Advice Letter 6678-E, 6678-E-A

**SUBJECT: Advice Letter Modifying Electric Rule 21 Pursuant to Resolution E 5172 and
PG&E's Request for Extension of Time to Comply with D.20-09-035 Ordering
Paragraphs 2 and 11 as Discussed in Resolution E-5172**

Advice 6678-E

Subject: Advice Letter Modifying Electric Rule 21 Pursuant to Resolution E-5172 and PG&E's Request for Extension of Time to Comply with D.20-09-035 Ordering Paragraphs 2 and 11 as Discussed in Resolution E-5172.

Figure Hh-2: Active Power as a Function of System Frequency

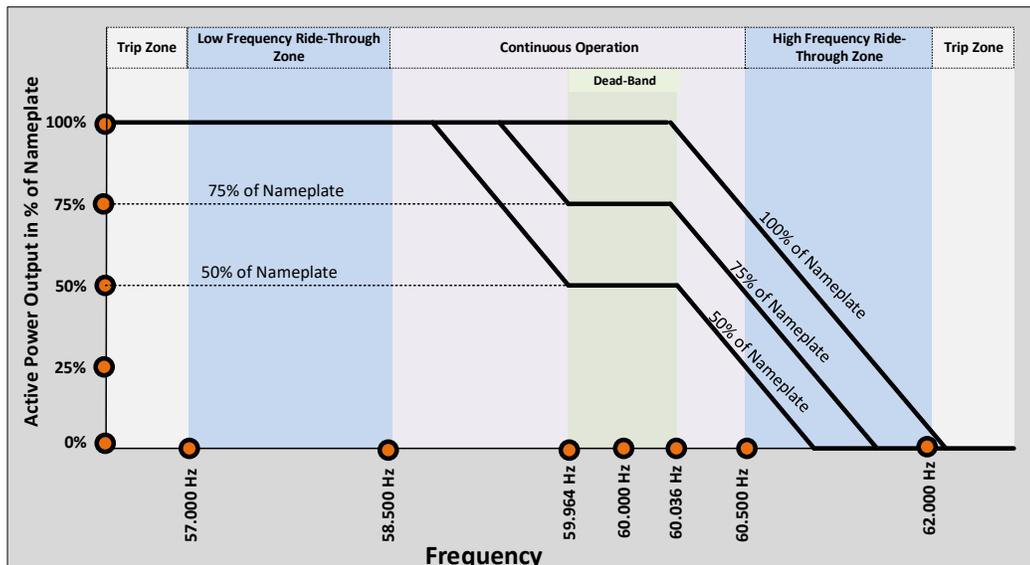
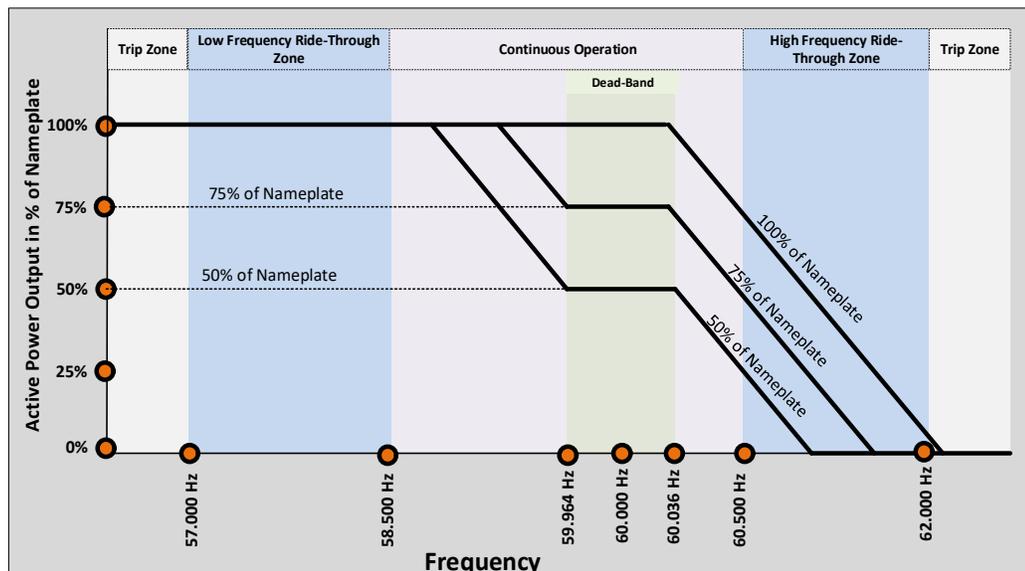
- When system frequency moves under 59.964 Hz, the active power output produced by the Smart Inverter shall be increased by 50% of real power nameplate rating per hertz (5% of real power nameplate rating increase per 0.1 hertz) when inverter is capable of increasing active power output.
- The default dead-band should be +/- 0.036 Hz from 60 Hertz (59.964 Hz to 60.036 Hz). When the system frequency is in range of 59.964 Hz and 60.036 Hz, the Smart Inverter is not required to decrease power as a function of system frequency.
- Open loop response time for Frequency –Watt shall be 5 seconds.
- Figure Hh-2 illustrated this requirement for three levels of output power. Figure Hh-2 is for illustration purposes only.

- When system frequency moves under 59.964 Hz, the active power output produced by the Smart Inverter shall be increased by 50% of real power nameplate rating per hertz (5% of real power nameplate rating increase per 0.1 hertz) when inverter is capable of increasing ~~real power production~~ active power output. (T)
- The default dead-band should be +/- 0.036 Hz from 60 Hertz (59.964 Hz to 60.036 Hz). When the system frequency is in range of 59.964 Hz and 60.036 Hz, the Smart Inverter is not required to decrease power as a function of system frequency.
- Open loop response time for Frequency –Watt shall be 5 seconds.
- Figure Hh-2 illustrated this requirement for three levels of output power. Figure Hh-2 is for illustration purposes only.
